**Before an Independent Hearings Commissioner appointed by  
the Kāpiti Coast District Council**

**Under** the Resource Management Act 1991 (Act)  
**In the matter** of an application under s 88 of the Act by Kāpiti Retail  
Holdings Limited for the construction and operation of a  
Countdown supermarket at 160 Kāpiti Road, Paraparaumu  
(RM210151)

**Statement of evidence of Michael Nixon on behalf of Young Supermarkets  
Limited and Modern Merchants Limited**

**Date:** 15 March 2022

Figure 1: Friendship Place Mitigation Works – 29 September 2021 S 92 Response

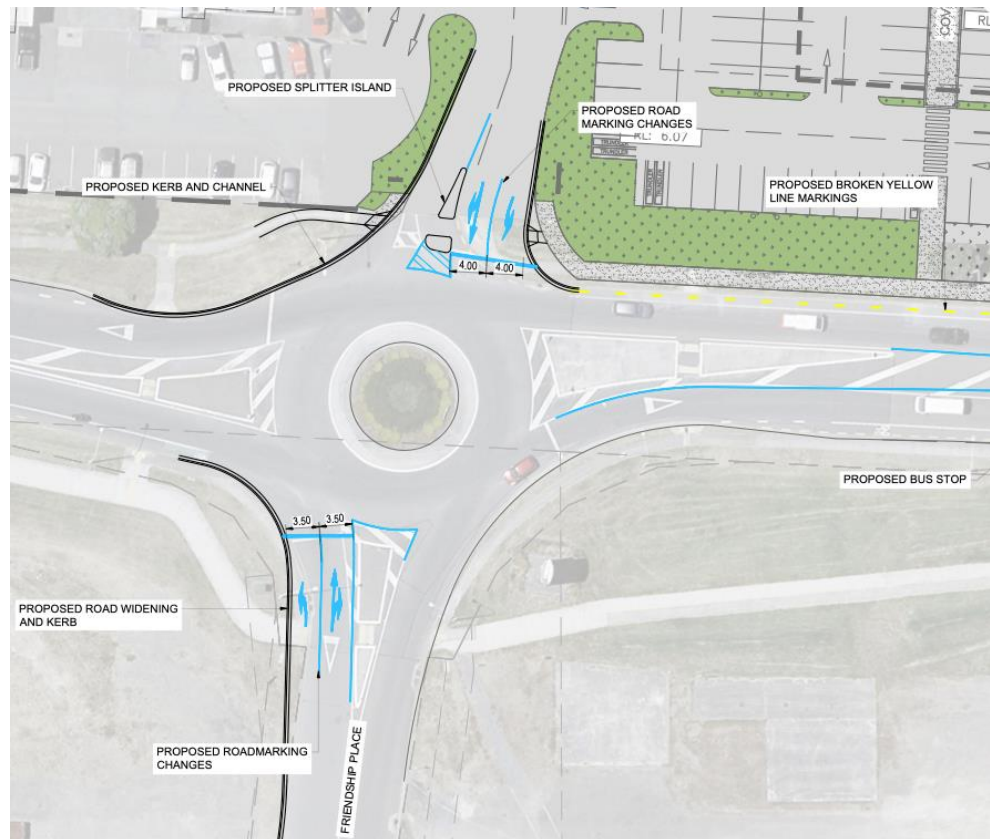
- 18 Regarding the proposed Friendship Place mitigation works, the additional left turn lane is very short. There is no specific standard for additional left turn lanes at roundabouts but good practice is to design for the queue storage length anticipated (as per Austroads design guidance), plus a 30m taper to tie into the adjacent lane (as per MOTSAM urban lane taper requirements).

- 19 I reiterate the point raised earlier in my evidence that while I can replicate the traffic modelling results of KRHL's transport specialist (Mr Kelly) even with a very short left turn lane, traffic models are an analysis tool only, and in my opinion should not be used to justify what I consider to be non-standard geometry.

- 20 I consider there is a risk that a safety audit (Condition 24) may recommend that the currently proposed left turn lane treatment needs to be lengthened.

- 21 For these reasons, I would like to see at this hearing some agreement between that parties that there is flexibility to achieve a more conventional additional left turn lane treatment on Friendship Place (as shown in the 29 September 2021 s 92 response). In this regard I note my earlier observations that the parties include the owner of the land within Kāpiti Landing, Templeton Kapiti Limited, and that the better design solution may require some of the works to be outside of the current road reserve on Templeton Kapiti Limited land. For clarity, the layout shown in the 29 September 2021 S 92 response is shown in Figure 1 overleaf.

- 25.1 The amended Condition 24 is acceptable in my opinion, however where the advice note refers back to the proposed works in Condition 1, I recommend these refer to drawing 21-005-SK001 Rev. B (this is the Friendship Place layout shown in the 29 September 2021 s 92 response); and
- 25.2 If a condition is proposed to address potential mitigation works on Kāpiti Road, I recommend that any potential adverse effects on entry movements to Friendship Place can be mitigated as soon as the effect is identified. I understand that this issue will need to be discussed in detail at the hearing.
